HISTORIC AND DESIGN REVIEW COMMISSION

June 07, 2017

HDRC CASE NO: 2017-243
ADDRESS: 3100 BROADWAY
LEGAL DESCRIPTION: NCB 3864 BLOCK 10 LOT 7
ZONING: C-2 RIO-1
CITY COUNCIL DIST.: 2
APPLICANT: Naeem Husain/Ezzi Signs
OWNER: Evan Ketabchi/Duwest Realty
TYPE OF WORK: New Signage
REQUEST:

20” CHANNEL LETTERS

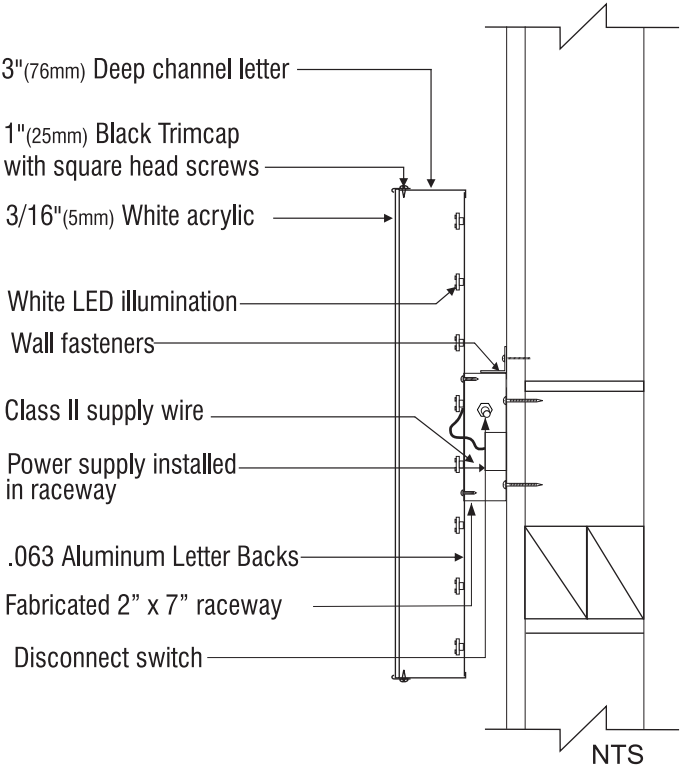
- b. WALL SIGN – On the western façade, the applicant has proposed to install an internally illuminated channel letter sign to read “Starbucks” to feature 16’ – 2” in length and 20” in height for a total of 26.9 square feet. The channel letters will feature aluminum cabinets with white acrylic faces. This sign is identified as sign A. The UDC Standards to properties located within the RIO allows for one major and two minor signs per the UDC Section 25-678. The proposed sign is consistent with the UDC.

60” ILLUMINATED SIREN

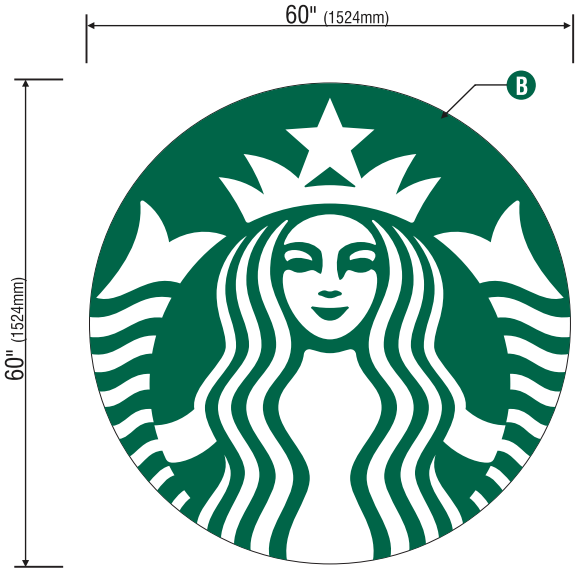
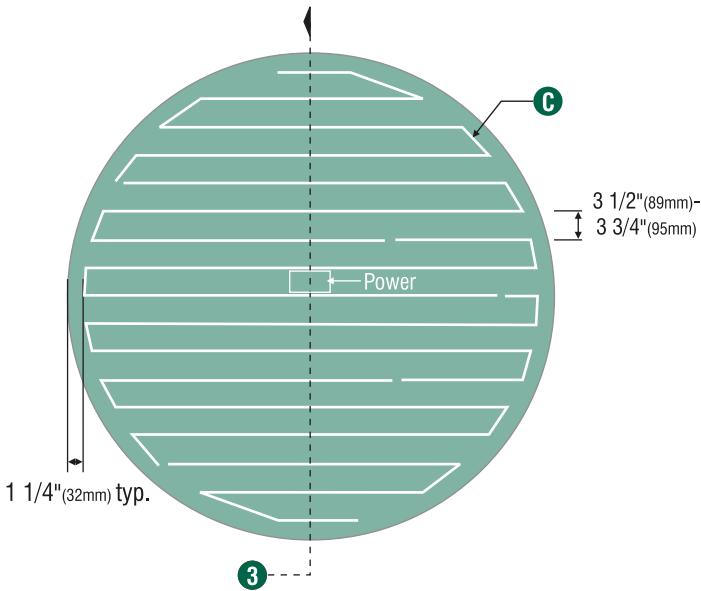
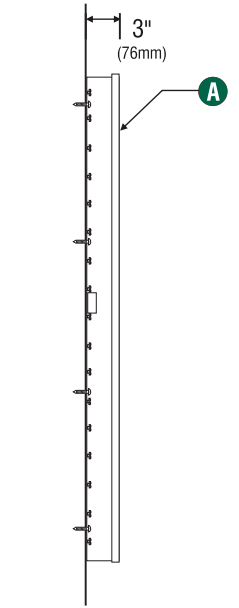
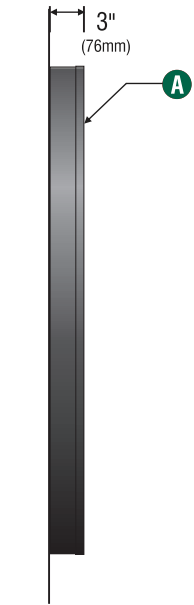
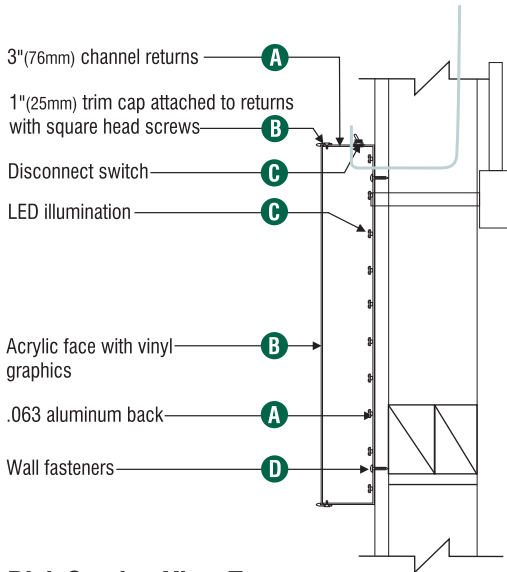
- c. DISK SIGN – On the south façade, the applicant has proposed to install an internally illuminated wall mount logo disk to feature 60” in height and width for a total square footage of 19.62 square feet. The wall mount logo disk will feature an aluminum cabinet with vinyl graphic faces. This sign is identified as sign B. The UDC Standards to properties located within the RIO allows for one major and two minor signs per the UDC Section 25-678. The proposed sign is consistent with the UDC.

48" DT WALL SIGN

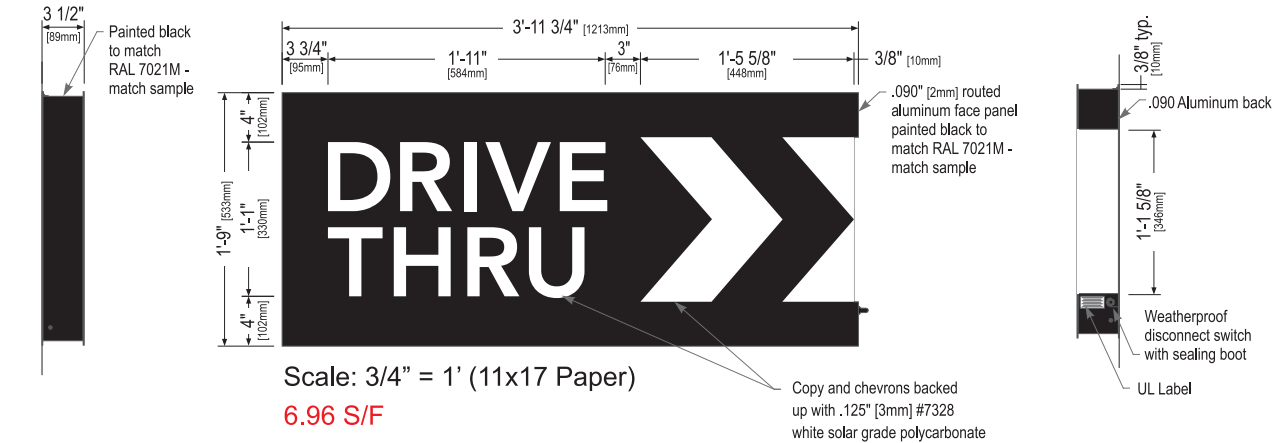
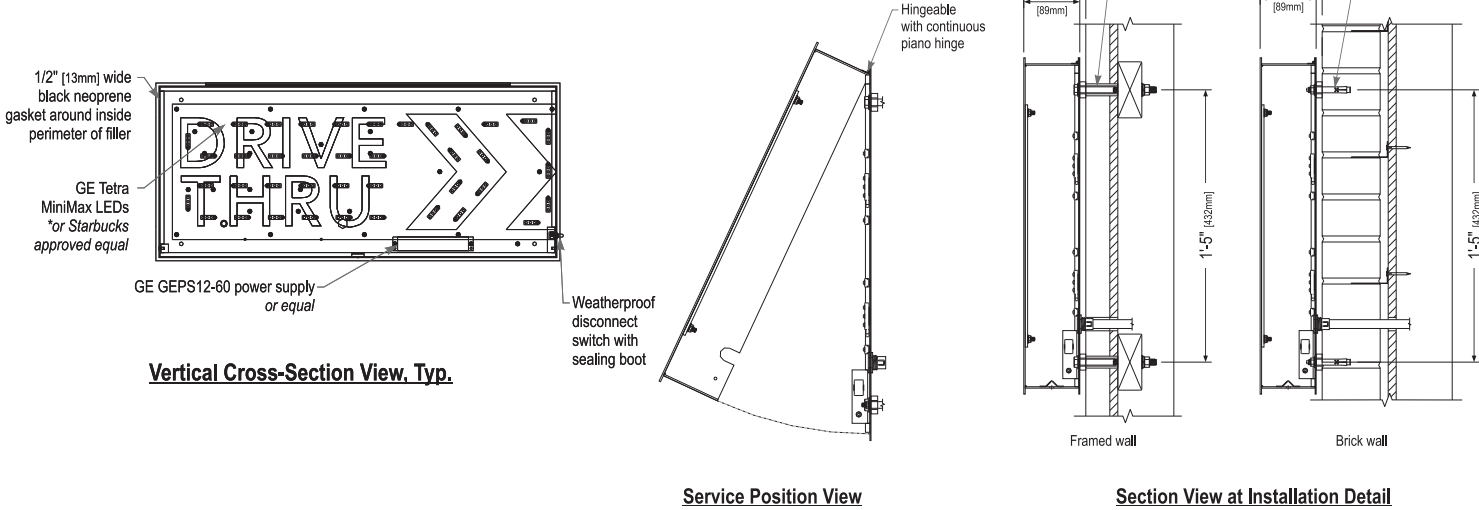
- d. DIRECTIONAL SIGNAGE – The applicant has proposed to install two direction signs for the drive through and on site traffic to feature “Drive Thru”, “Thank You” and “Exit Only”. Both signs are to feature approximately 7 and 8 square feet, will be internally illuminated and will feature aluminum cabinets. These signs will not feature the company’s commercial logo. Sign C will be wall mounted and sign D will be free standing and located between the building entrance and outdoor seating area. Per the UDC Section 35-678(f), parking lot signs identifying entrances and exits to parking area or driveways when there is one traffic flow are not to be included in the total signage area provided that no corporate or business logo is included within these signs. The applicant’s proposal is consistent with the Guidelines.

46” ILLUMINATED DIRECTIONAL <DT / DT>

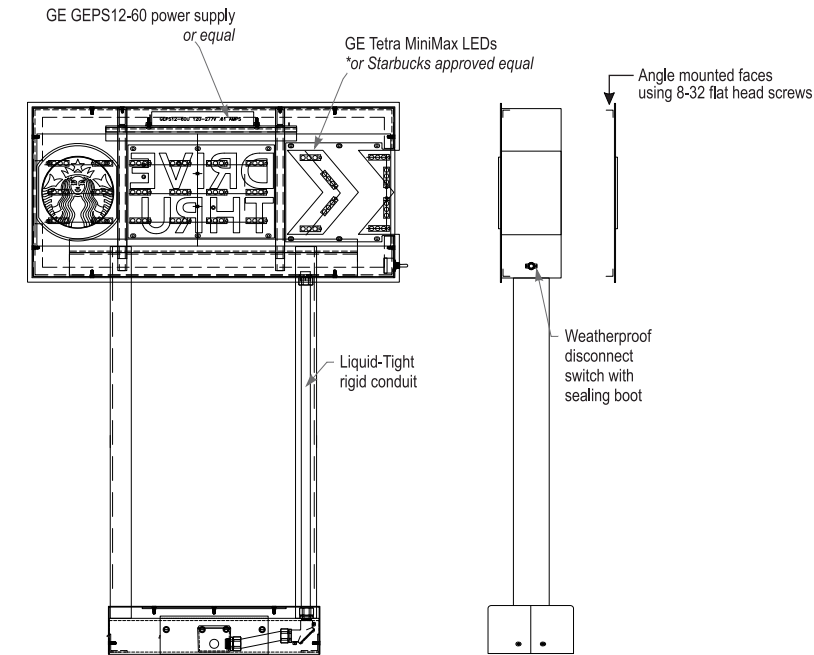
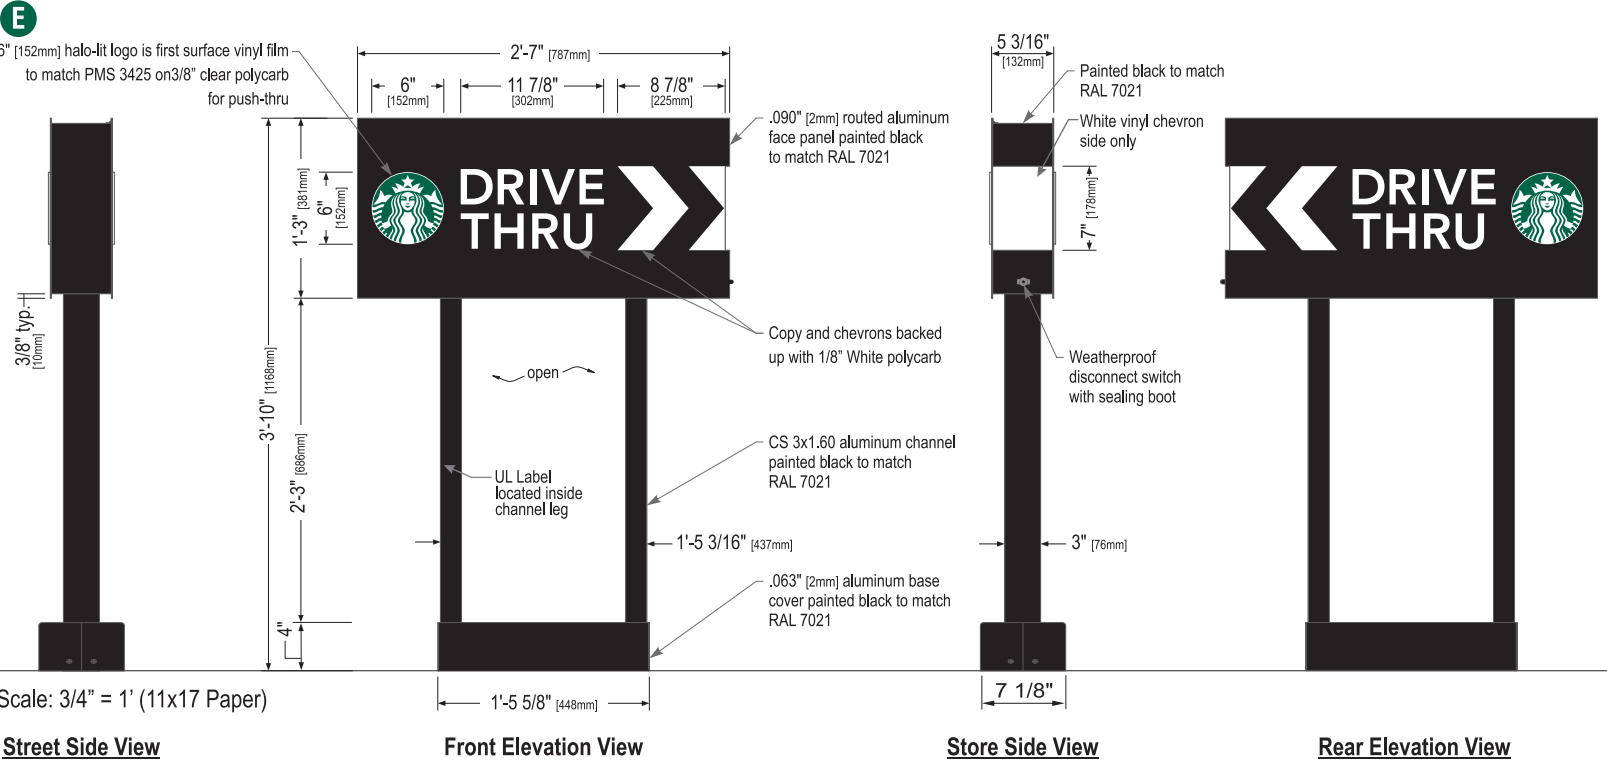
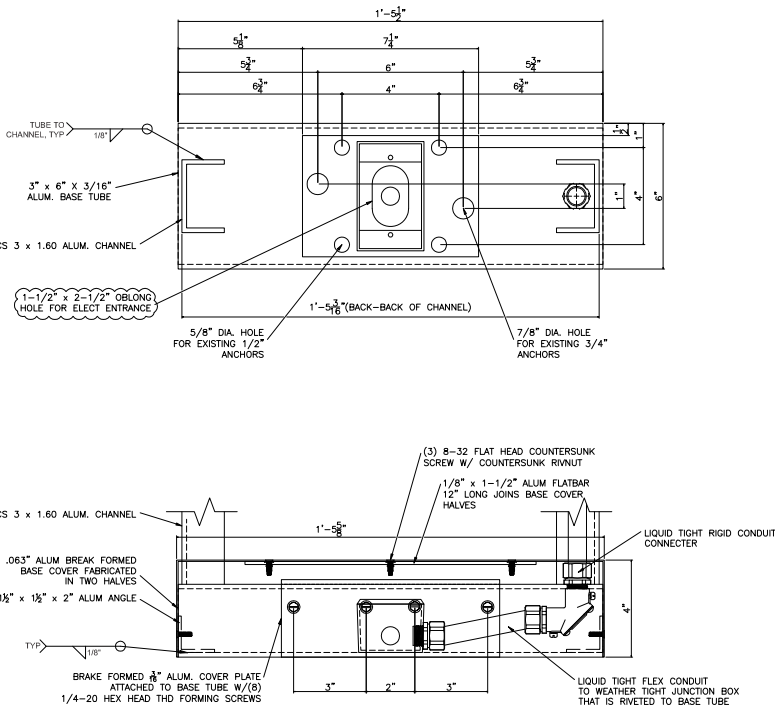
- e. DIRECTIONAL SIGNAGE – The applicant has proposed to install one internally illuminated drive through sign to feature text that reads “Drive Thru” the company’s commercial logo, an aluminum cabinet and approximately 10 square feet in size. The sign is identified as sign E and will be located on a parking island internal to the site. The inclusion of the company logo on this directional sign requires it to be included in the total square footage on the site; however, at a total of ten square feet, staff finds the proposed sign appropriate given the size of the site and the location at the rear of the site.

CLEARANCE BAR SBC S14106-SHB-10

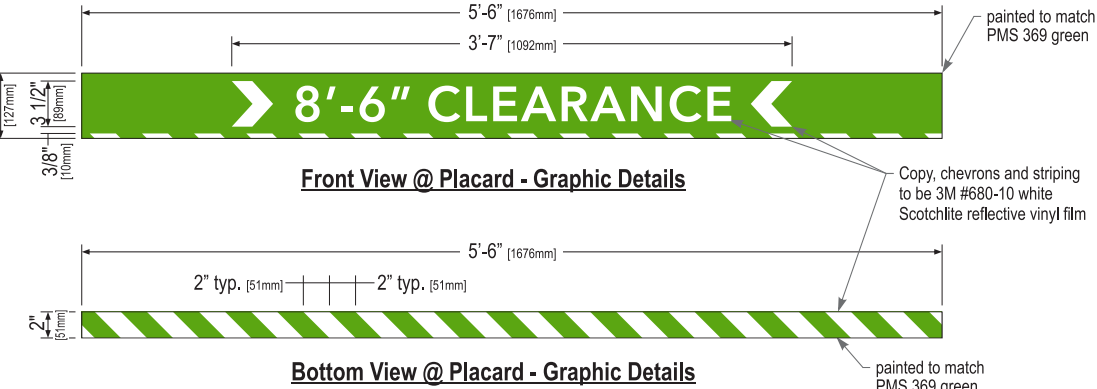
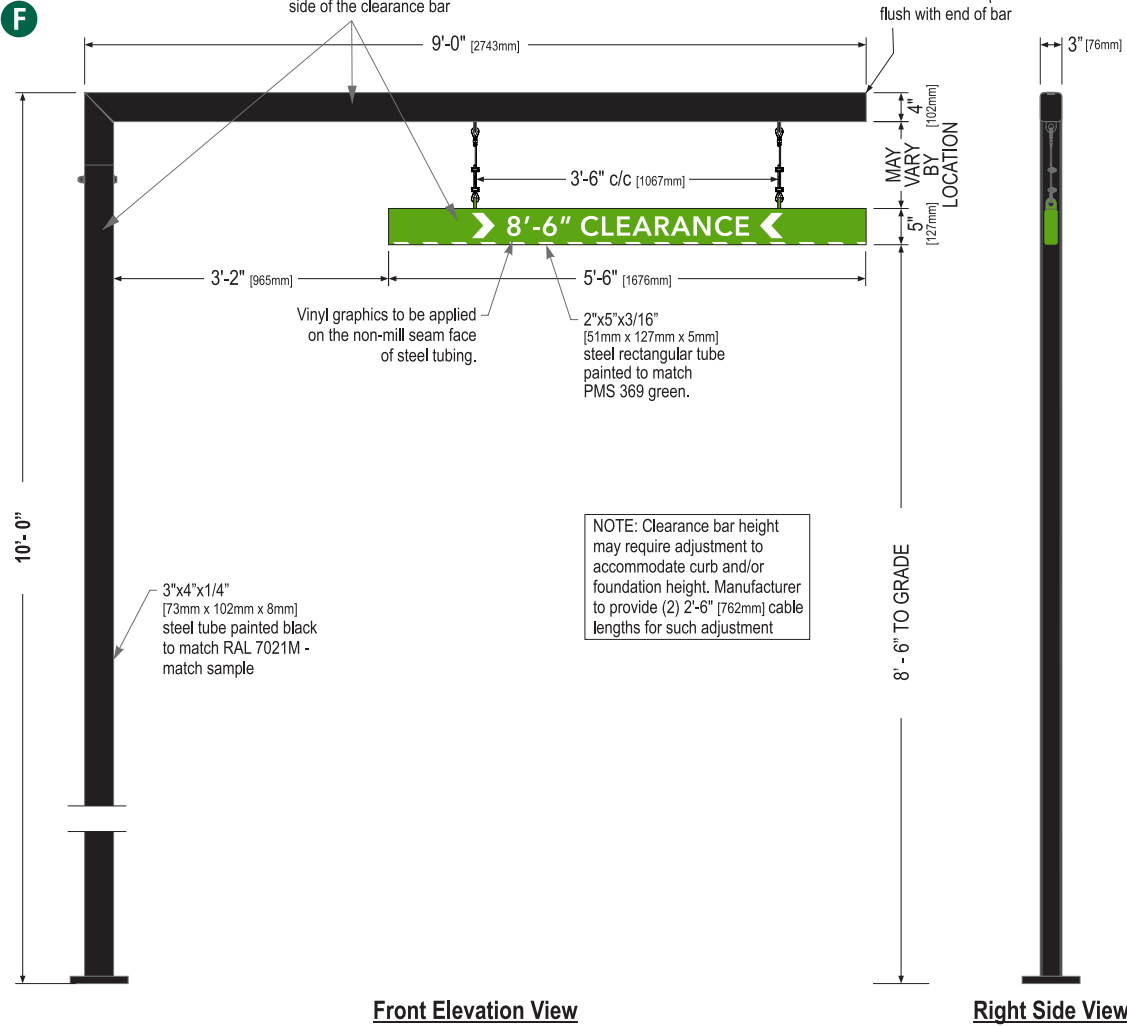
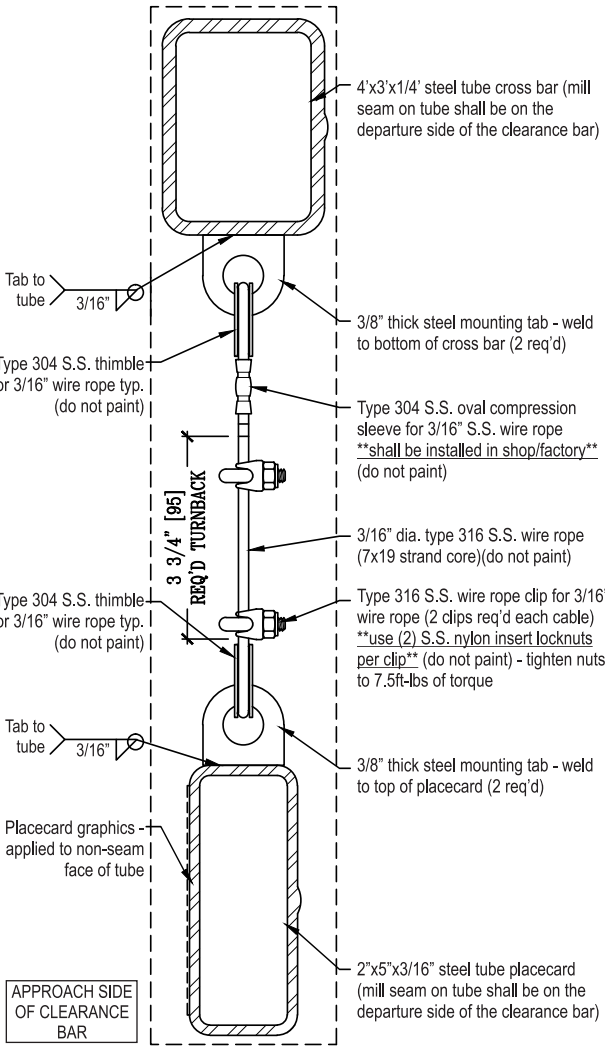
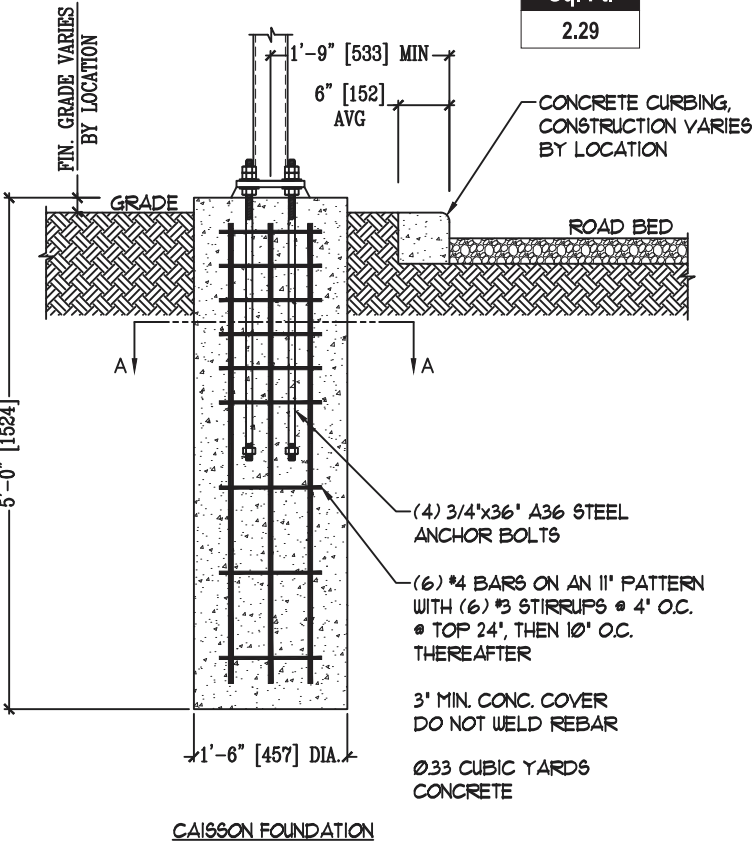
- f. CLEARANCE BAR – In the drive through lane, the applicant has proposed to install one drive through clearance bar with clearance signage to read “8’6” Clearance” and to be painted green. This sign is identified as sign F. Staff finds this signage appropriate.

TENANT PANELS - OPTION A

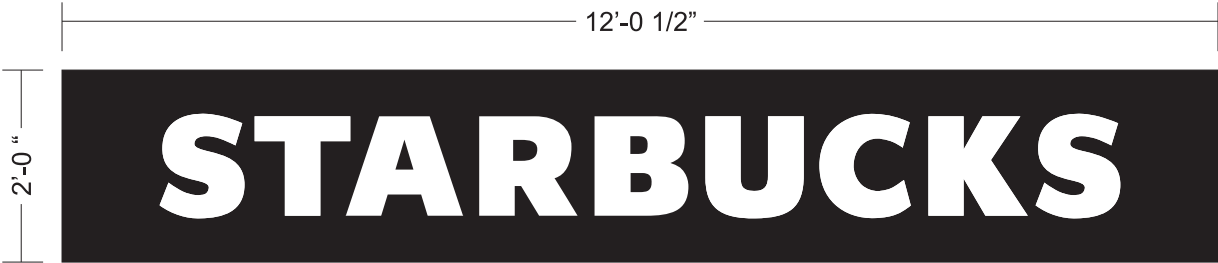
- g. MONUMENT SIGN FACE – The applicant has proposed to install new signage faces on the existing monument sign cabinet. The applicant has proposed two options. Both options A and B include approximately twenty-four (24) square feet per side. Staff finds either option to be appropriate and consistent with the UDC.
